NTSB No. CEN15MA290

Airbus Helicopters Service Bulletin No. AS350-67.00.64 (63 Pages)

SUBJECT: ROTOR FLIGHT CONTROLS - Double hydraulic servocontrols

"HYDR" test indication for double hydraulic servocontrols
 Corresponds to modification 074622

Figure 18

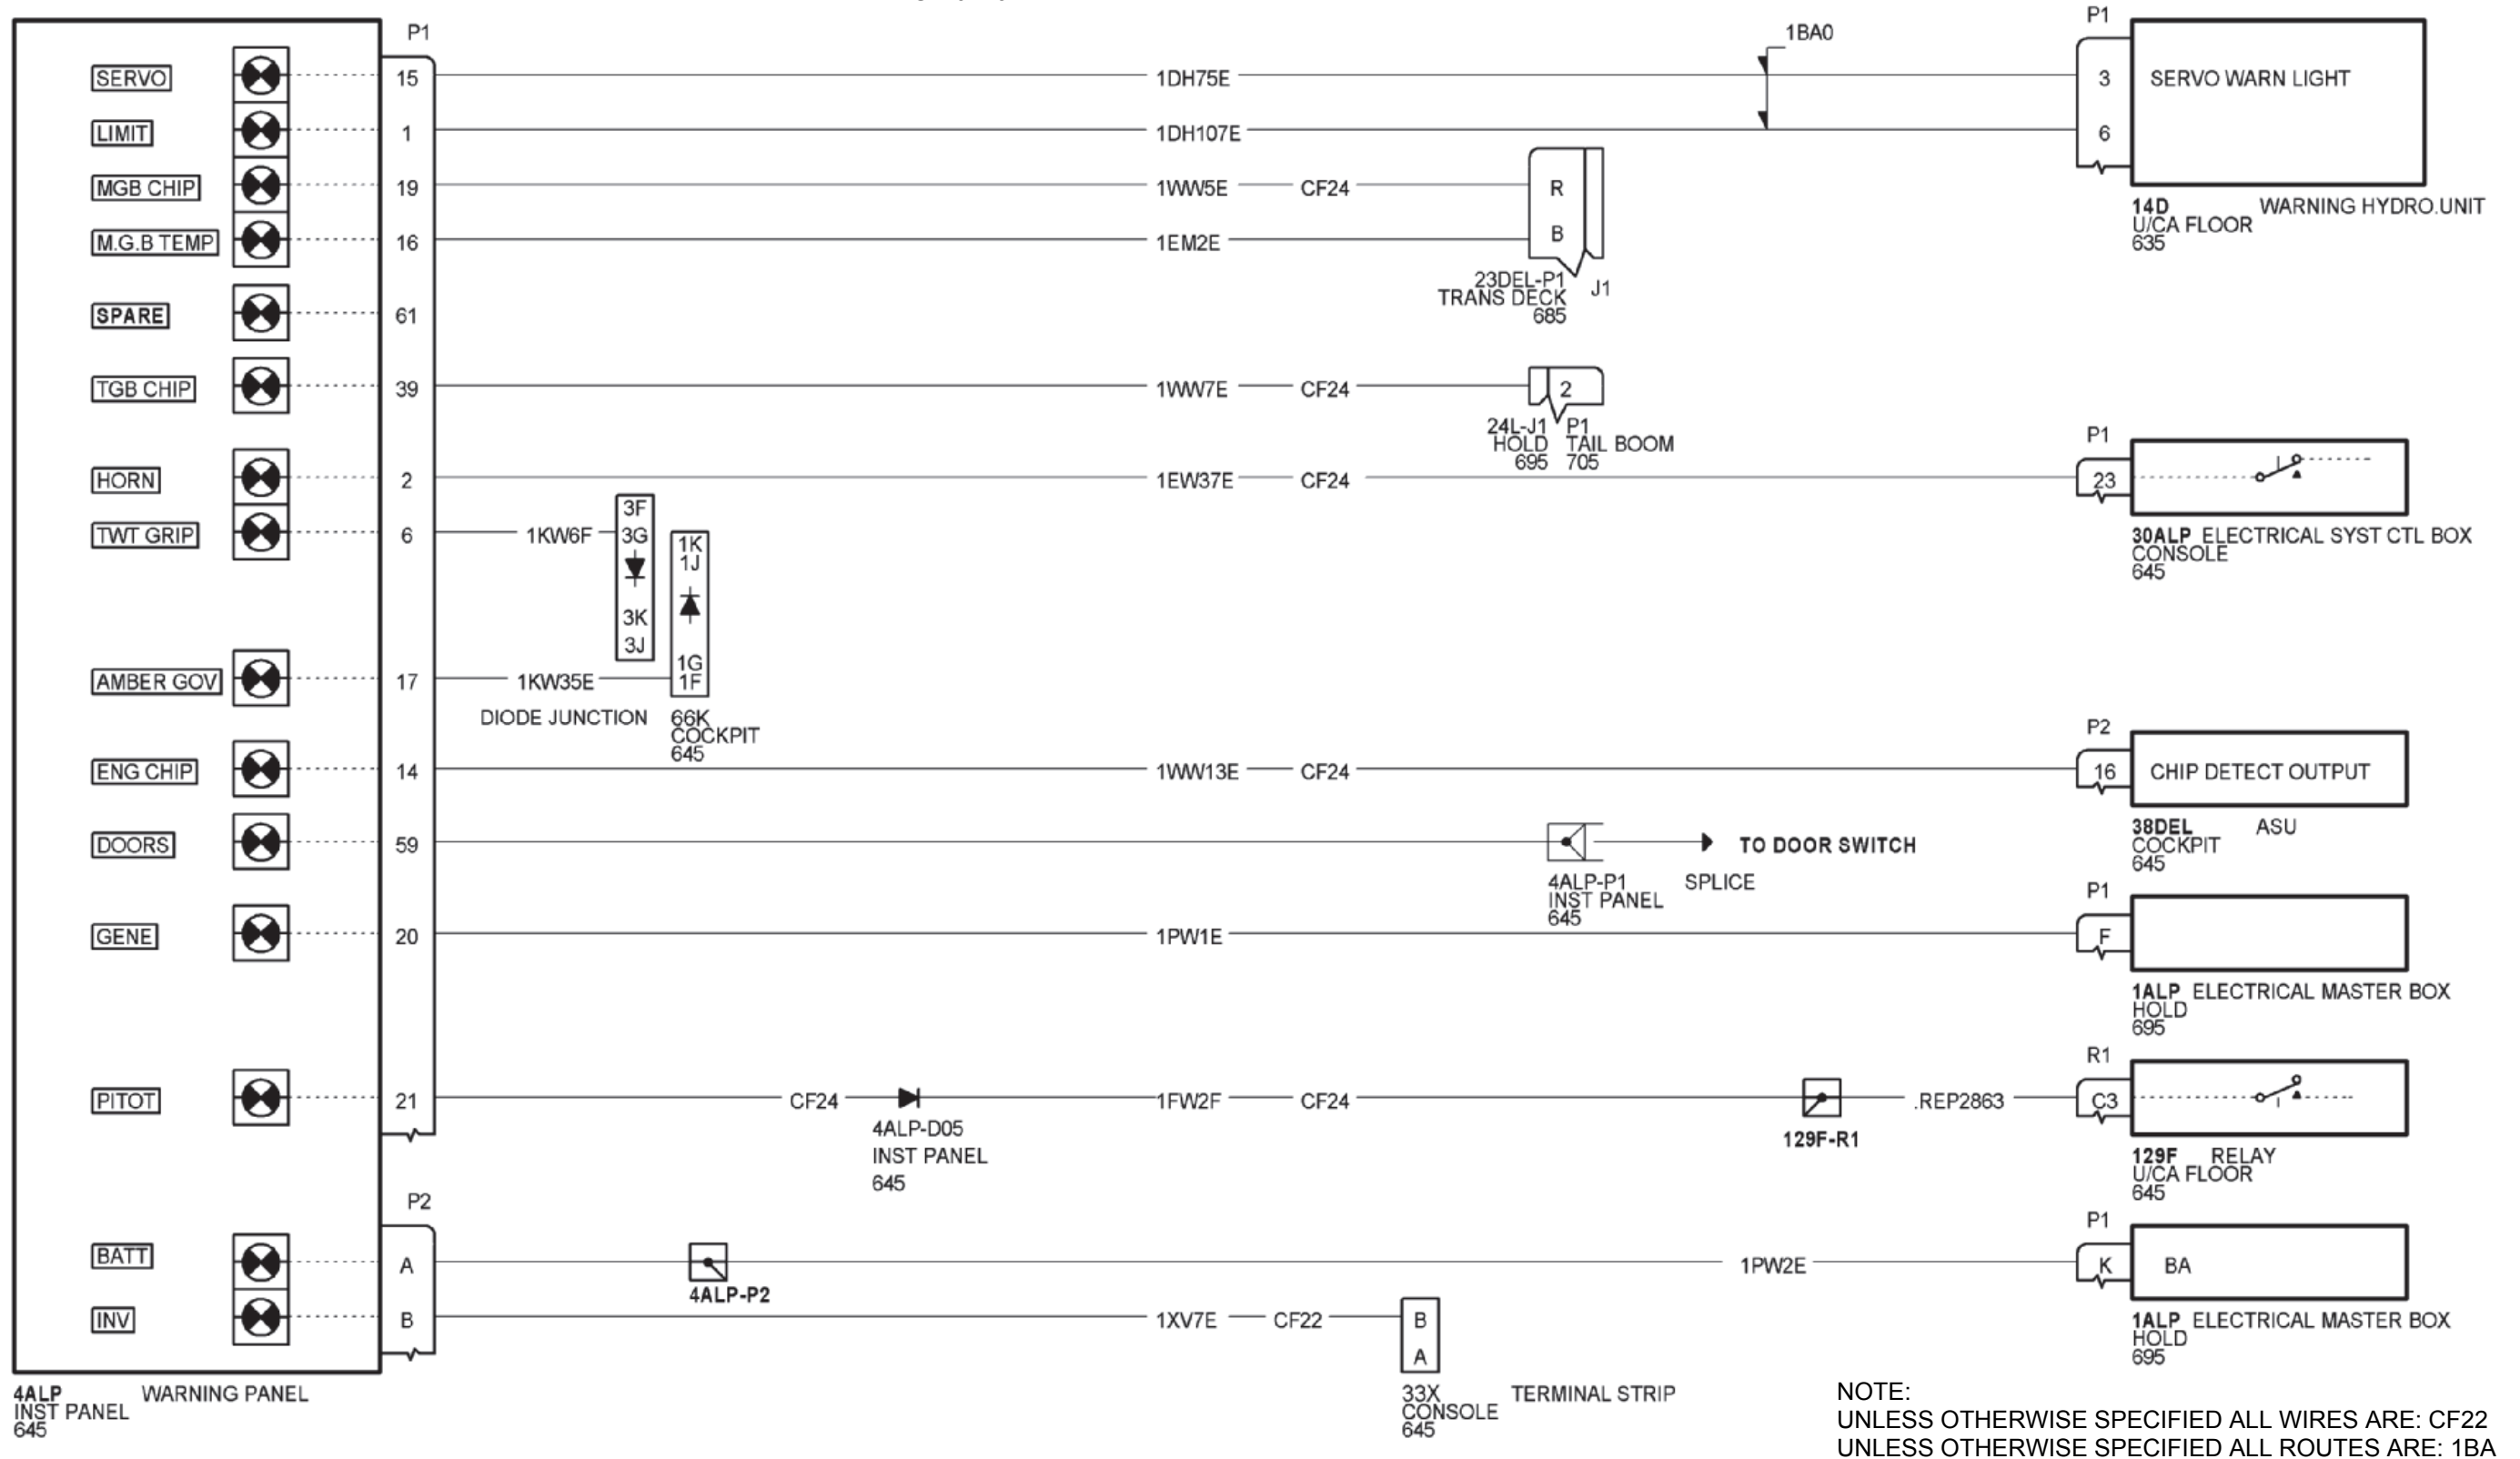
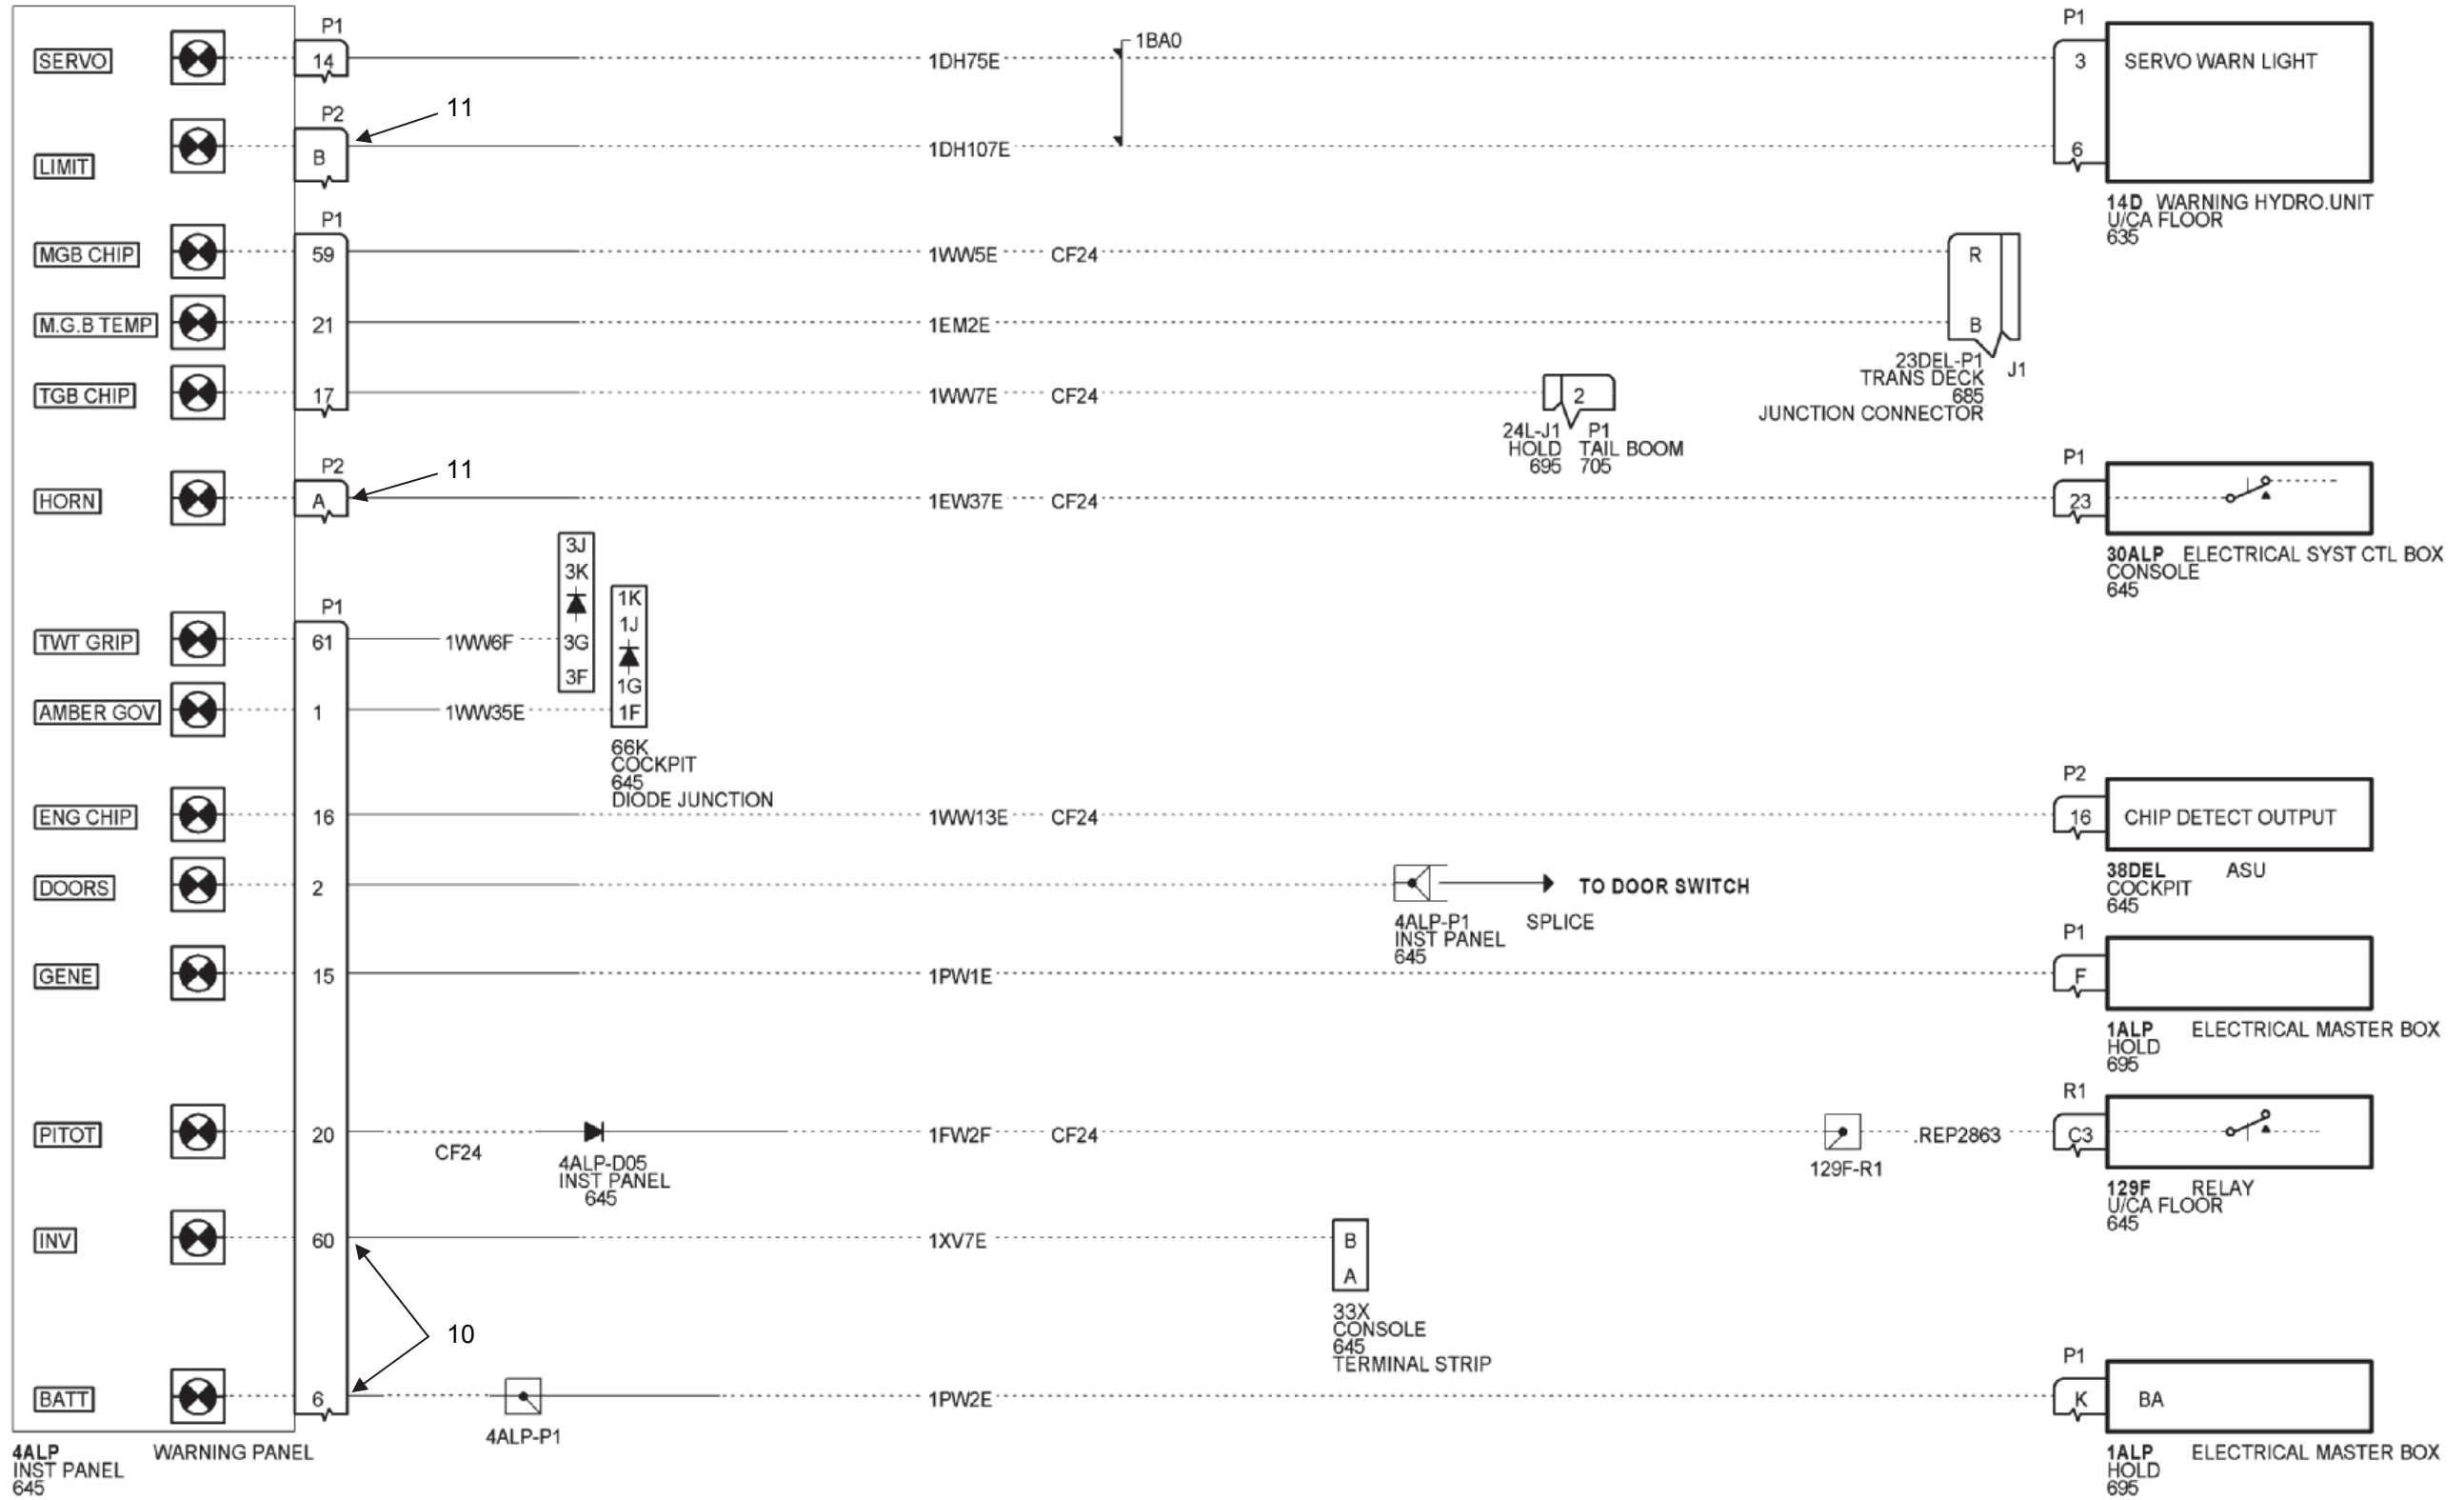
3.B.2.b.6. For helicopters POST MOD 073368 and POST MOD 073391 and PRE MOD 073450
(Figures 1, 15, 16, 17, 18 and 19)

- Cut and discard the binding clamps (not shown on Figures) that hold the electrical harnesses.
- Install base (3) on relay support (14) (Figure 1) with its nuts and bolts.
- Route the wiring using sets of wires and markers (17) and wire to contacts (4), (8), (10) and (11), ground contacts (12) (refer to appendix 4.A.), PCB (CI) contacts (18) (refer to appendix 4.B.) and extensions (9) and (19) as per Figures 15, 16, 17, 18 and 19.
- Carry out a continuity test of the modified wiring.
- Install timer relay (2) on base (3).
- Attach the electrical harnesses with binding clamps (31) or (32) (not shown on Figures).

Figure 20 – A.P. fixed parts

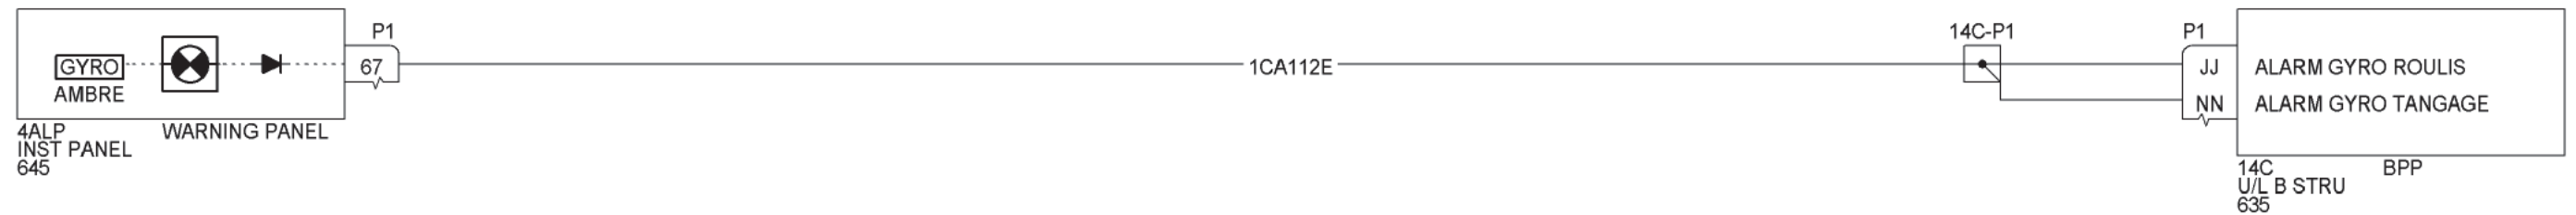
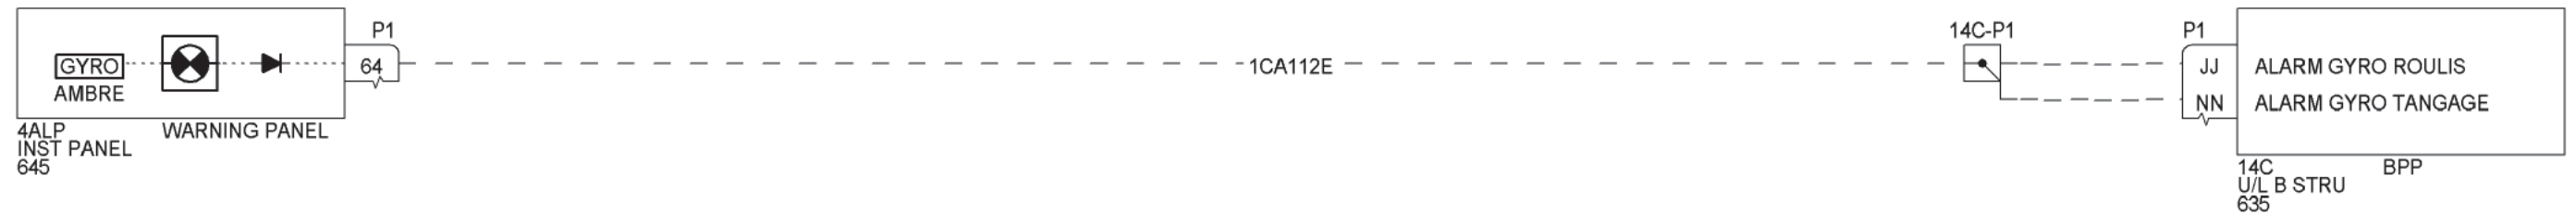
3.B.2.b.7. For helicopters with A.P. fixed parts (Figure 20)

- Modify wiring as per Figure 20.
- Carry out a continuity test of the modified wiring.
